INTERIM CHANGE REQUEST

Plan Title/Rev. Unit 1 ISI Program Plan Rev 4 ICR No. ISI-IR4-02

Reason for Change: Implementation of the IRFOS ISI Outage Plan has identified several examination items that have had calibration block changes, have been added, deleted or rescheduled or that require relief requests.
The changes requested maintain ISI Plan compliance with ASME Section XI requirements for sample percentages, schedules and examination methods.

RELIEF REQUEST
B-9

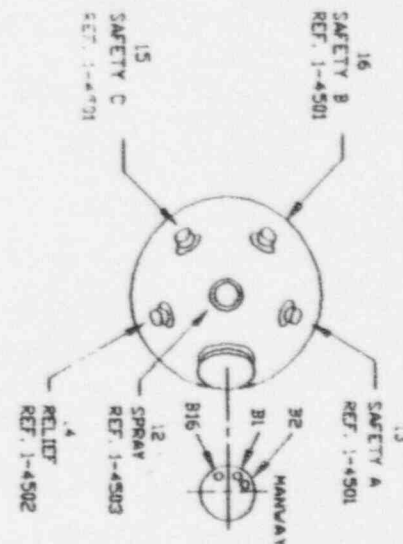
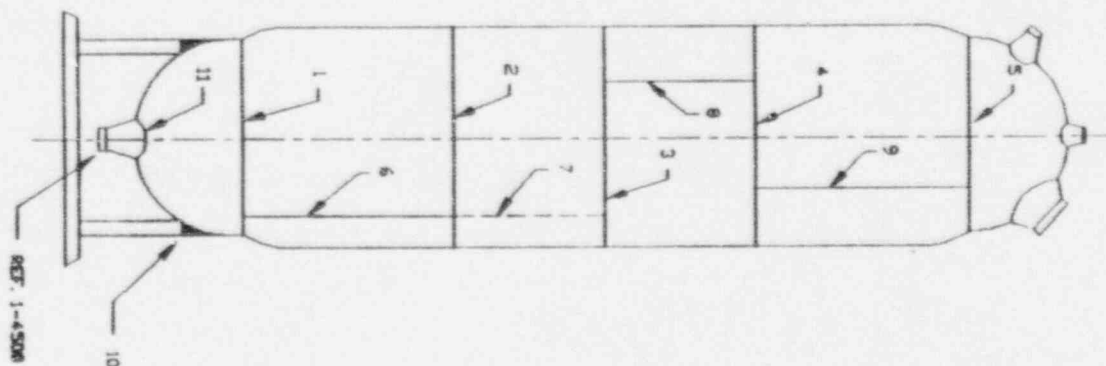
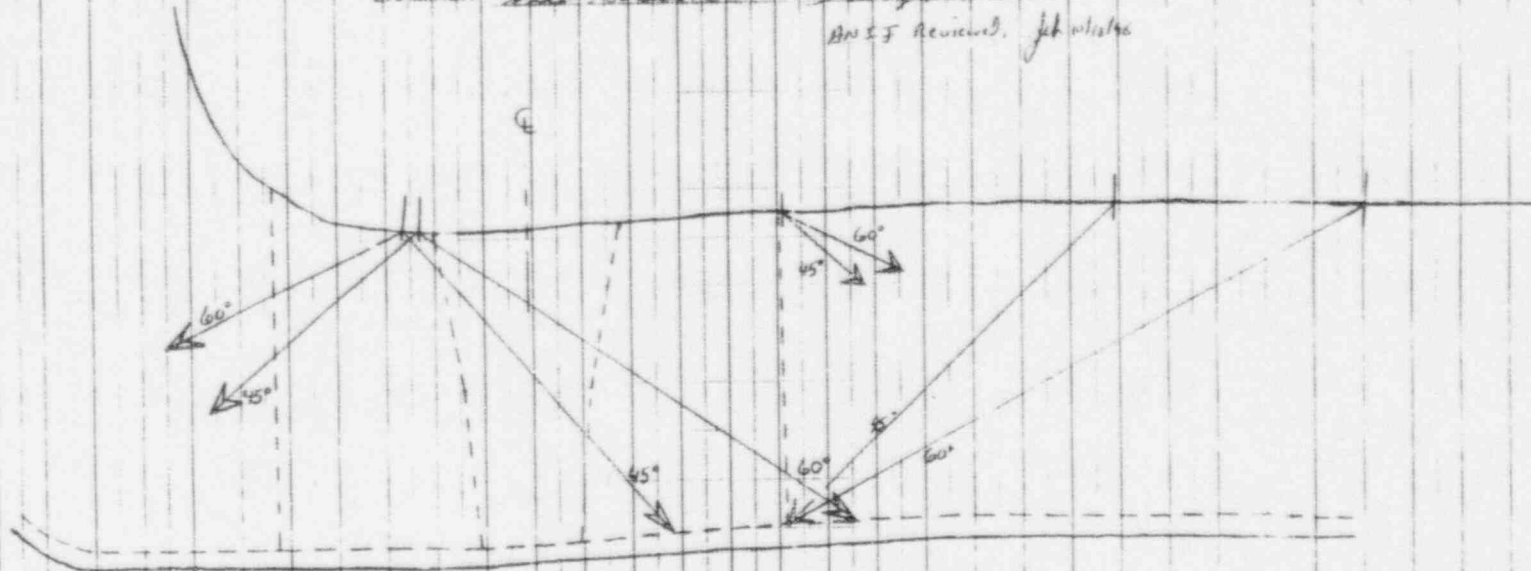
The specific examination area geometries of these nozzle to vessel welds preclude the complete ultrasonic examinations of the volume required by Fig. IWB-2500-7. Approximately 26% of each of TBX-1-2100-12, 13, 14, 15, 16, the spray, safety and relief nozzle welds, did not receive the full code required coverage. Additional pressurizer heater interferences resulted in approximately 48% of TBX-1-2100-11, the surge nozzle weld, not receiving the full code required coverage. See pages 2 through 9 for weld location and examination area configuration.

Best effort examinations consisting of two separate angel beams were performed. Full circumferential scan and 0 degree straight beam coverage was obtained for all of the subject welds and required base metal areas. Axial scan coverage was achieved in at least one beam path direction with two different beam angles for 93% of each of the spray, safety and relief nozzle welds and for 65% of the surge nozzle weld. Axial scan coverage was achieved in at least one beam path direction with one beam angle for the 96% of each of the spray, safety and relief nozzle welds and for 80% of the surge nozzle weld.

PLANT COMANCHE PEAK UNIT 1 SKETCH TBX-1-2100 Rev 2
 SYST/COMP PRESSURIZER WELD IDENT 12 RELATED TO UT PROCEDURE TX-151-210 Rev 3
 EXAMINER John Holbrook JR George A. Malone DATE 10-14-96

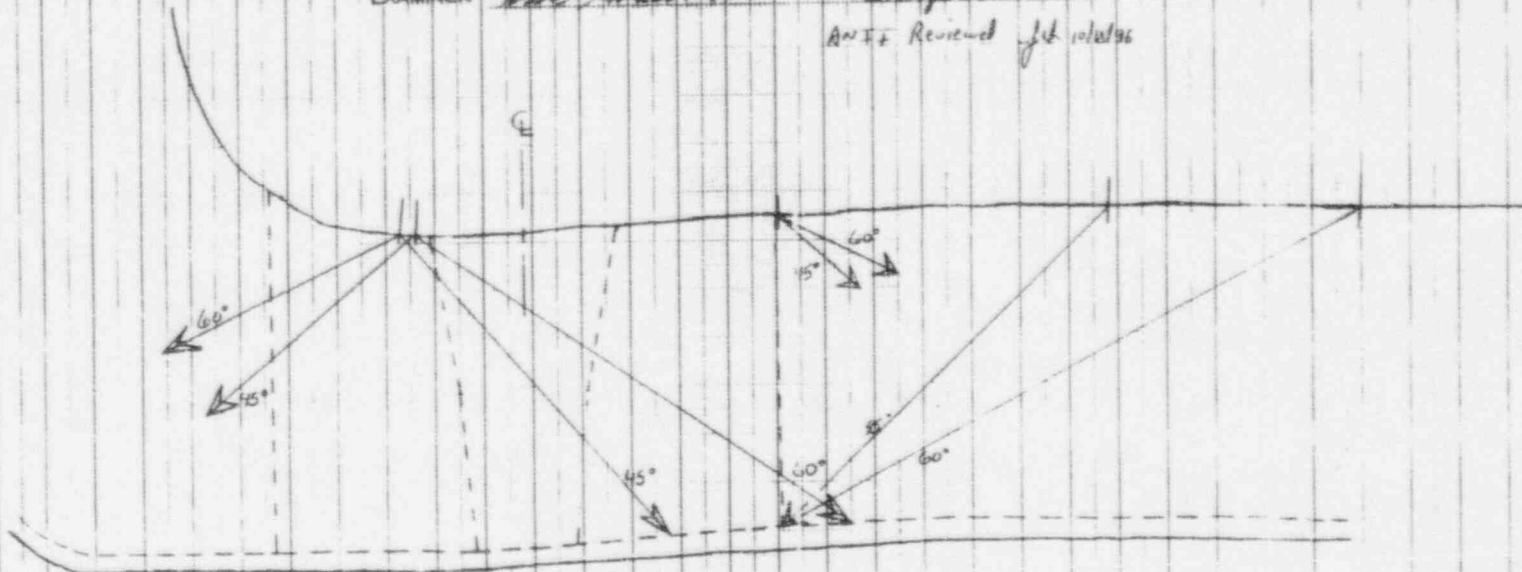
26 % REQUIRED EXAMINATION VOLUME NOT COVERED

93 % REQUIRED EXAMINATION VOLUME COVERED IN AT LEAST ONE BEAM PATH DIRECTION WITH TWO DIFFERENT BEAM ANGLES

96 % REQUIRED EXAMINATION VOLUME COVERED IN AT LEAST ONE BEAM PATH DIRECTION WITH ONE BEAM ANGLE

PLANT COMANCHE PEAK UNIT I SPEC. TBX-1-2100 Rev 2
 SYST COMP PRESSURIZER WELD IDENT. 16 RELATED TO UT PROCEDURE TX-ISI-210 Rev 3
 EXAMINER John Holbrook George A. McQuinn DATE 10-14-96

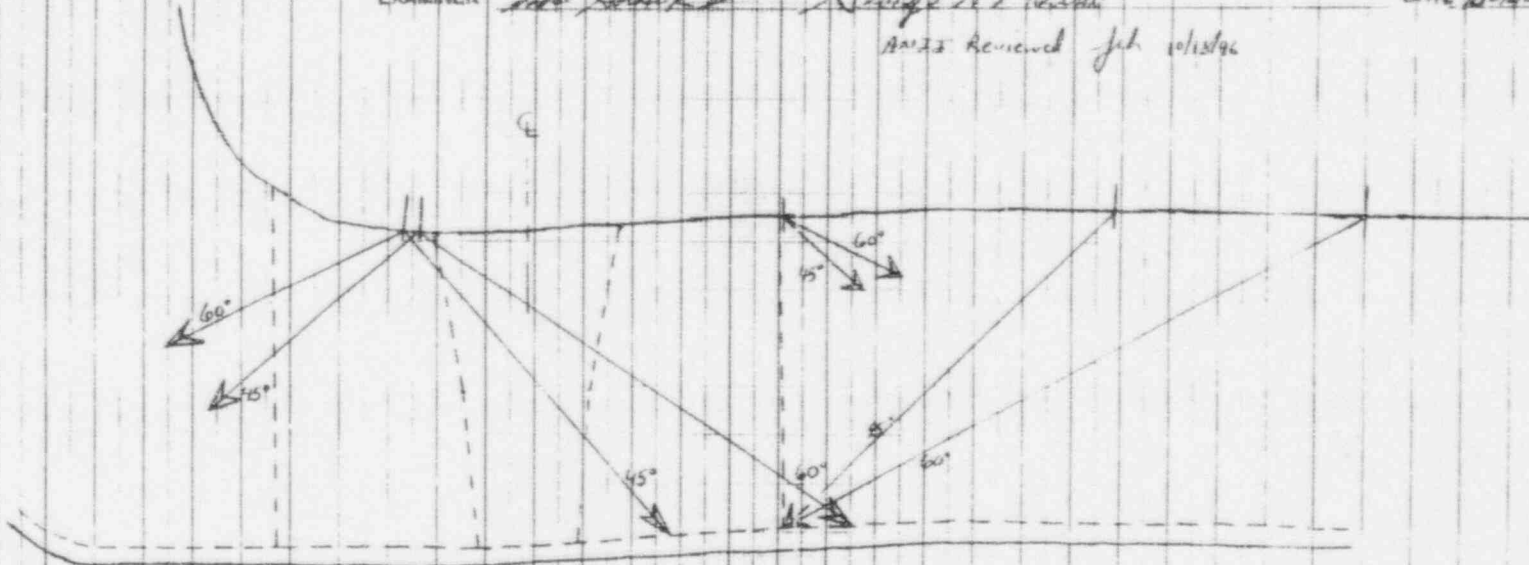
26	% REQUIRED EXAMINATION VOLUME NOT COVERED
93	% REQUIRED EXAMINATION VOLUME COVERED IN AT LEAST ONE BEAM PATH DIRECTION WITH TWO DIFFERENT BEAM ANGLES
96	% REQUIRED EXAMINATION VOLUME COVERED IN AT LEAST ONE BEAM PATH DIRECTION WITH ONE BEAM ANGLE

PLANT	COMANCHE PEAK	UNIT	1	SKETCH	TBX-1 2100 REV 2
SYSTEM/COMPONENT	PRESSURIZER	WELD IDENTITY	11	RELATED TO	UT
EXAMINER	Paul S. Bieche		PROCEDURE	TX-IS-210 REV 3	
			DATE	10-27-96

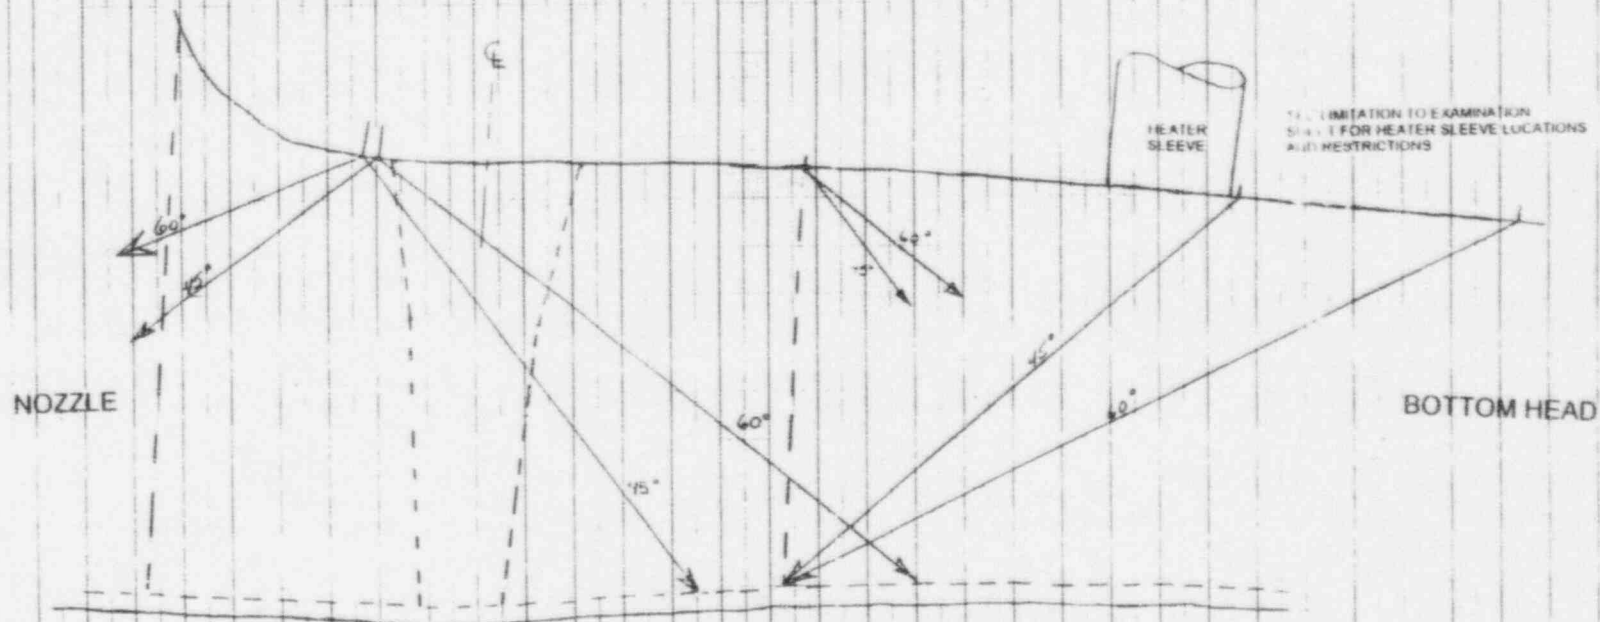
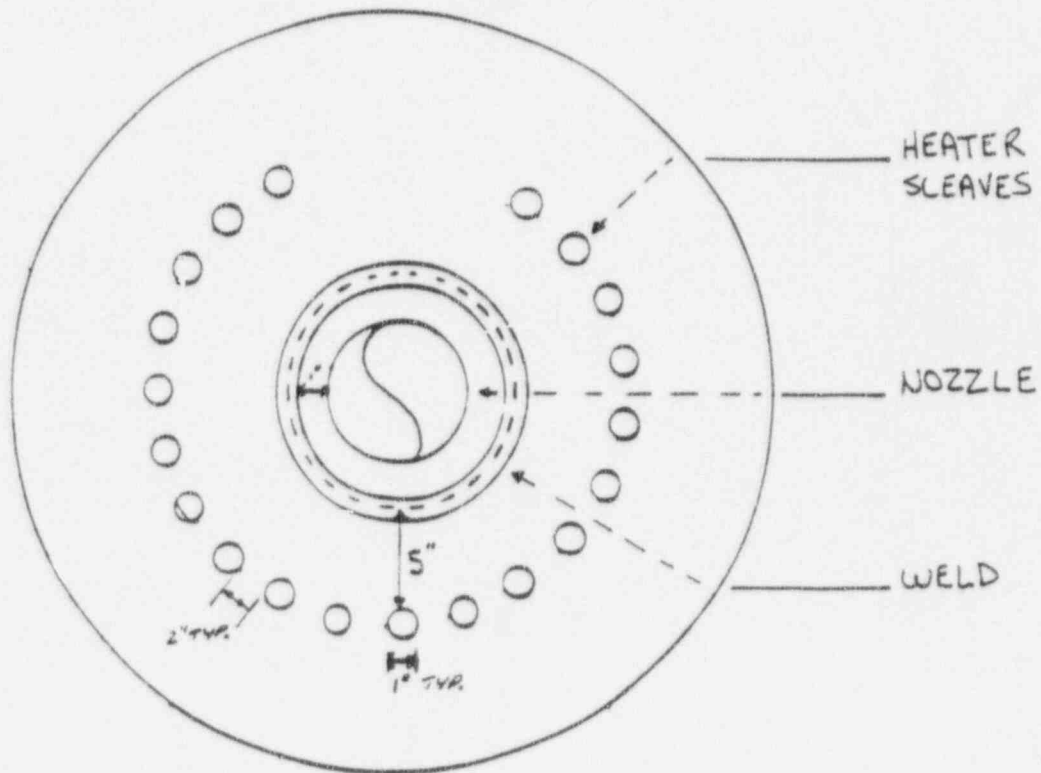
WELD CONFIGURATION LIMITS ALL SCANS, HEATER SLEEVE LIMITS 5 SCANS

48 % REQUIRED EXAMINATION VOLUME NOT COVERED

65 % REQUIRED EXAMINATION VOLUME COVERED IN AT LEAST ONE BEAM PATH DIRECTIN WITH TWO DIFFERENT BEAM ANGLES.

80 % REQUIRED EXAMINATION VOLUME COVERED IN AT LEAST ONE BEAM PATH DIRECTIN WITH ONE BEAM ANGLE.

PLANT COMANCHE PEAK UNIT 1 SKETCH TBX-1-4104 REV 1SYST./COMP. SAFETY INJECTION PROCEDURE TX-ISI-214 REV. 1EXAMINER Paul S Blecker DATE 10-27-96RELATED TO: UT X PT MT VT IDENT. NO. 1

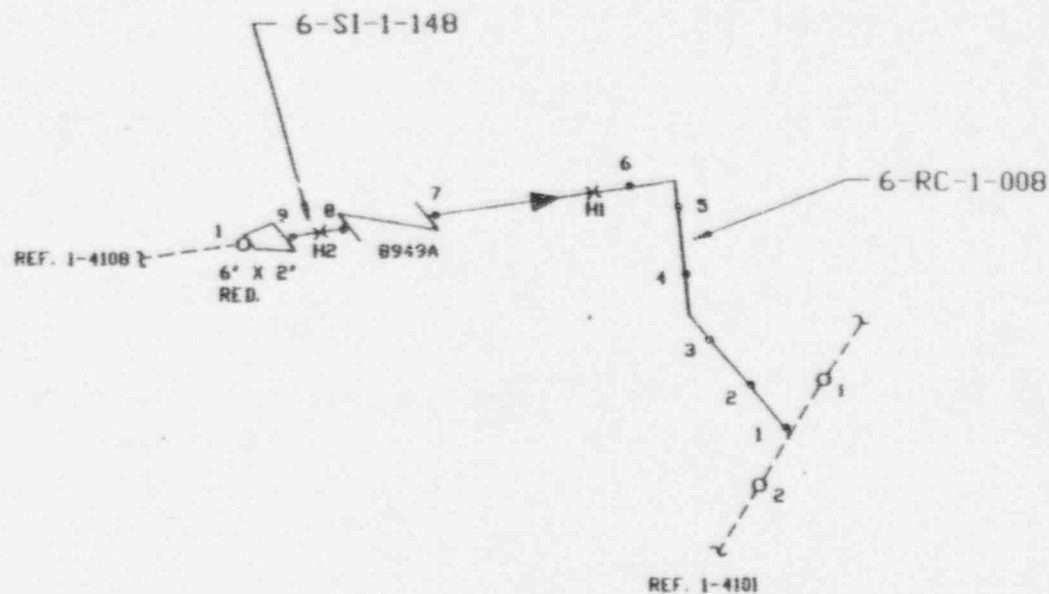
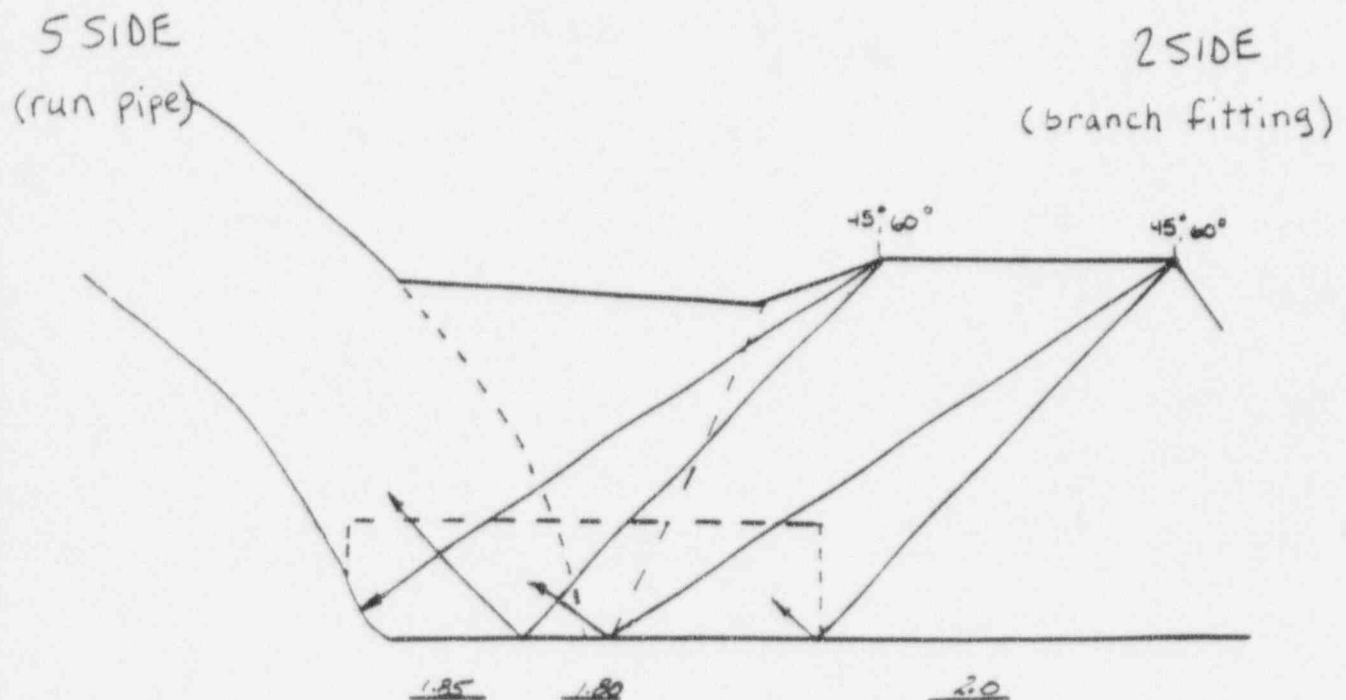
The specific examination area geometry of this pipe to branch connection weld precludes the complete ultrasonic examination of the volume required by Fig. IWB-2500-10. Approximately 23% of the examination volume did not receive the full code required coverage.

23% OF THE REQUIRED EXAMINATION VOLUME IS NOT COVERED IN 2 BEAM PATH DIRECTIONS

100% OF THE REQUIRED EXAMINATION VOLUME IS COVERED IN AT LEAST 1 BEAM PATH DIRECTION

PLANT COMANCHE PEAK UNIT 1 SKETCH TBX-1-4201 REV 1
SYST./COMP. ACCUMULATOR DISCHARGE PROCEDURE TX-ISI-214 REV 1
EXAMINER CBF DATE 10-17-96

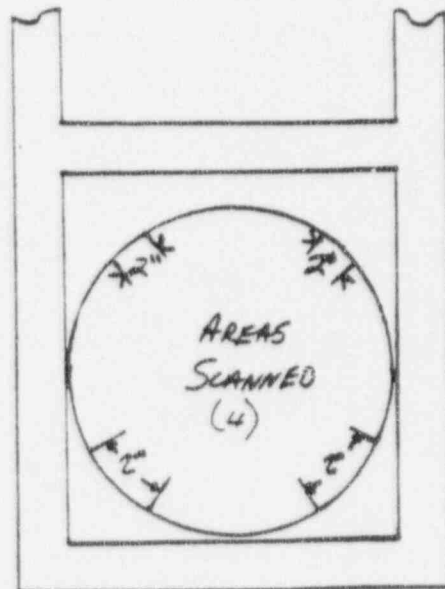
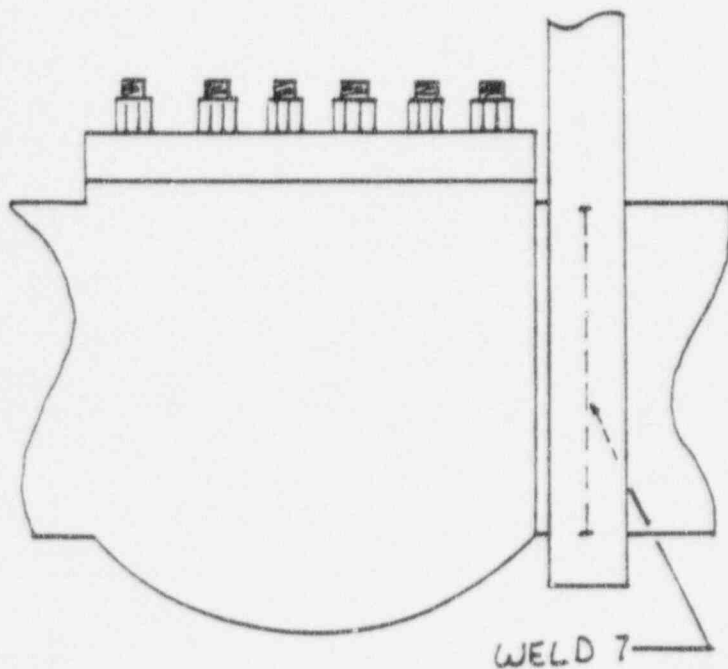
SUPPORT RESTRICTS ALL SCANS FOR UT.

70% NOT COVERED UT.

PLANT COMANCHE PEAK UNIT 1 SKETCH TBX-1-4201 REV 1
SYST./COMP. ACCUMULATOR DISCHARGE PROCEDURE TX-ISI-11 REV 6
EXAMINER Paul S Black DATE 10-17-96

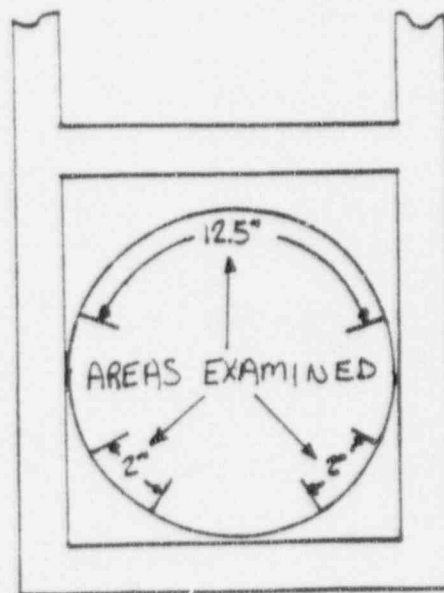
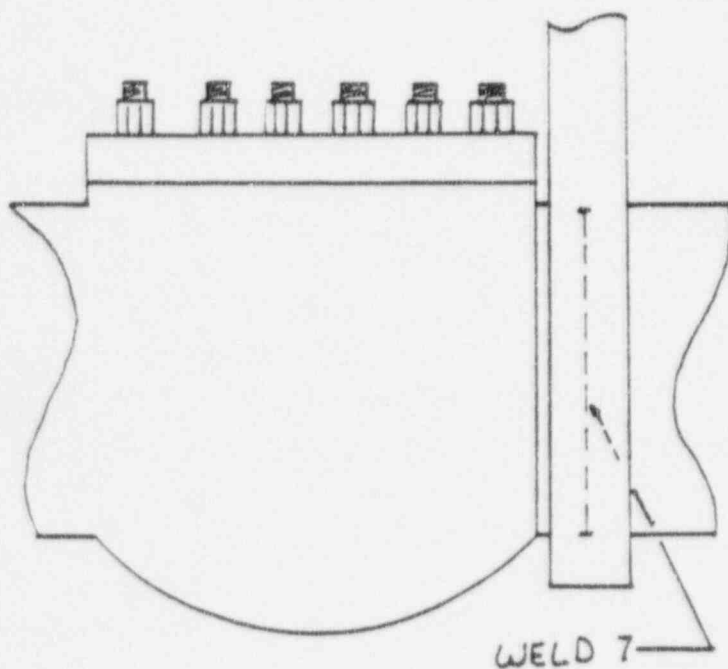
SUPPORT RESTRICTS ACCESSIBILITY FOR PT EXAM.

48% NOT COVERED.
